PCN – Process Change Notification

Change:	GP.1575.15.4.B.02
Date:	2018/08/06
Author	Bonnie Chen

Model#	Part Number	Changes
GPS Patch Antenna 1575MHz Ceramic Patch	GP.1575.15.4.B.02	Update drawing.

Illustration of Change

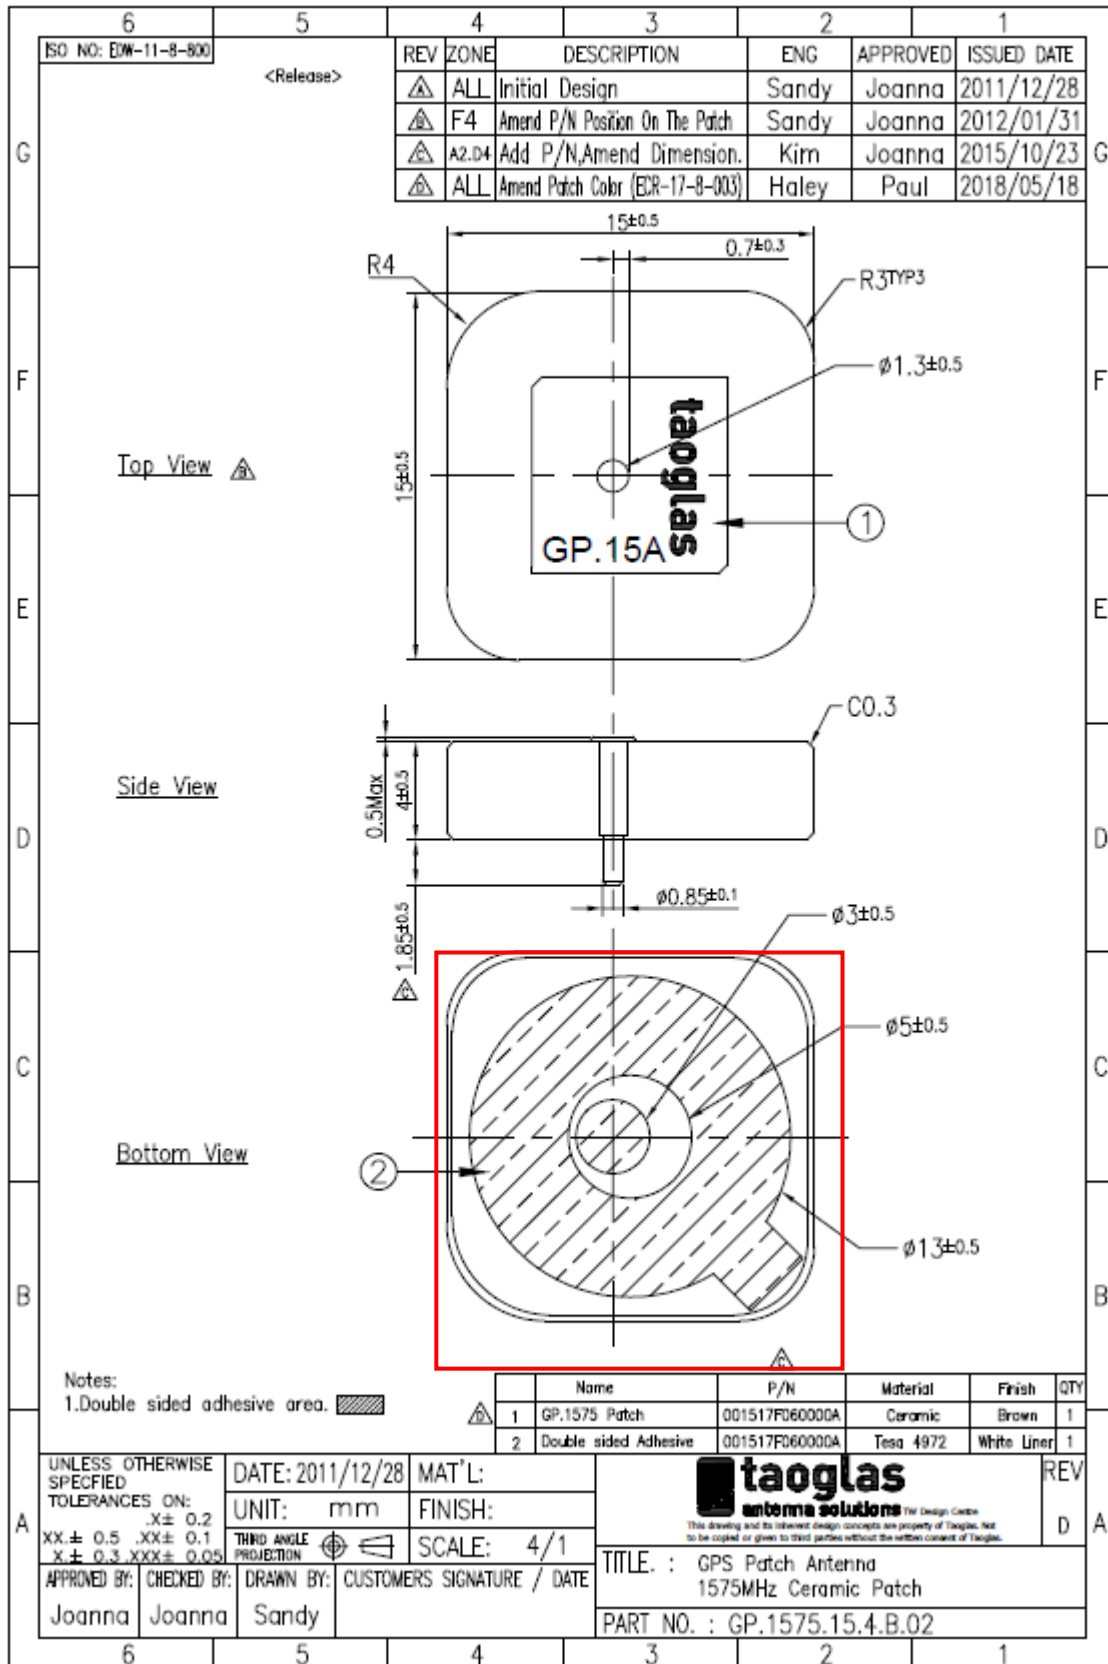
- The back side tape orientation is changed compared to original drawing.
- Original: The tear-off tag orientation is at right bottom
 - New: The tear-off tag orientation is at right top.
